Park District of Highland Park

2021 Sunset Valley Golf Club Cart Path Bridge Fabrication

ADDENDUM # 1

October 15, 2021

SHEET NUMBER:
S-7
 OF 9 SHEETS

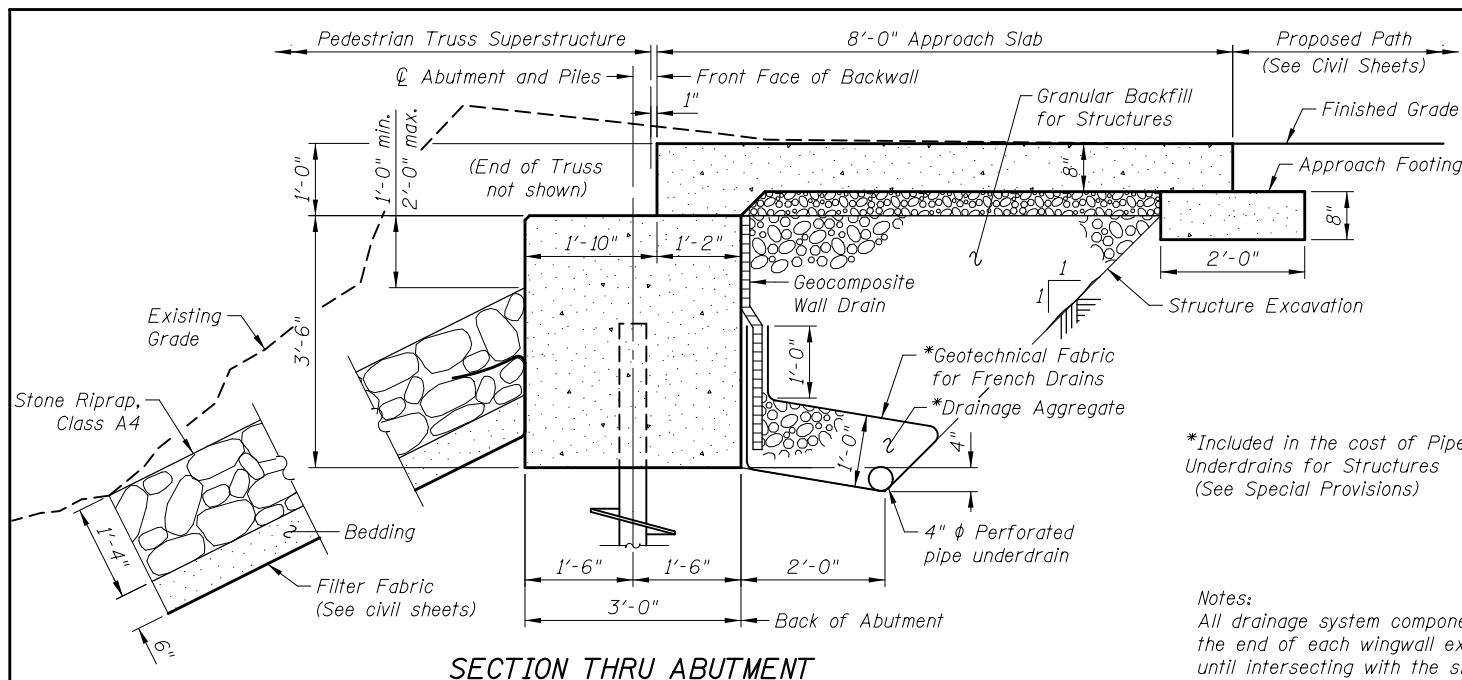
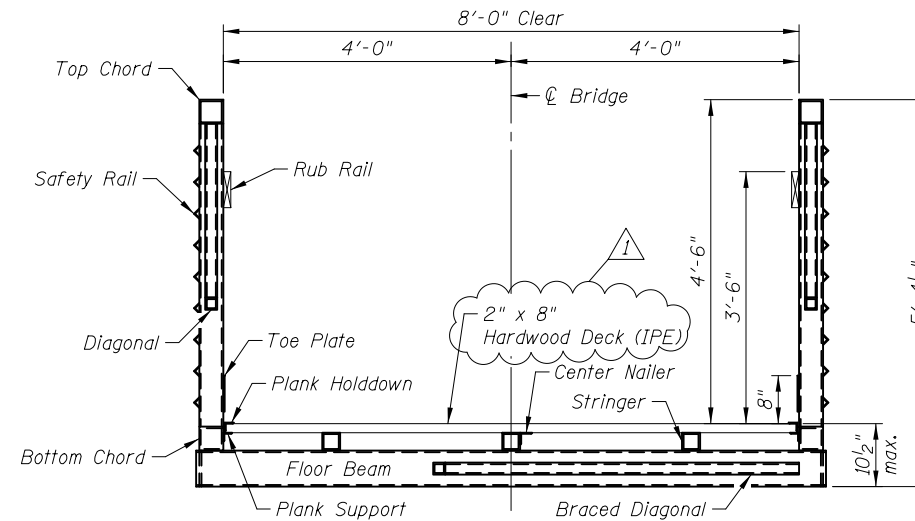
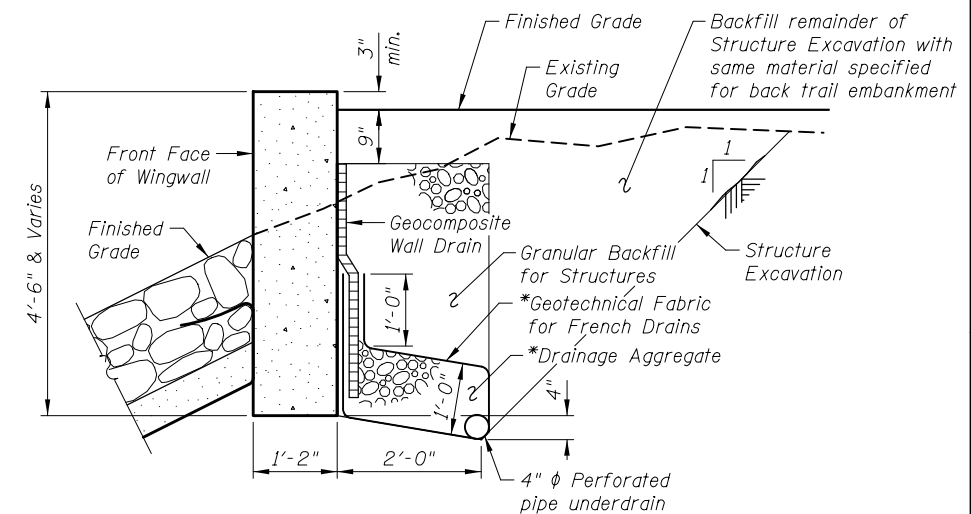
Item #2 – Replacement of Sheet S-7 General Details of drawings to amend the plank size of the hardwood deck to now be 2” x 8”.
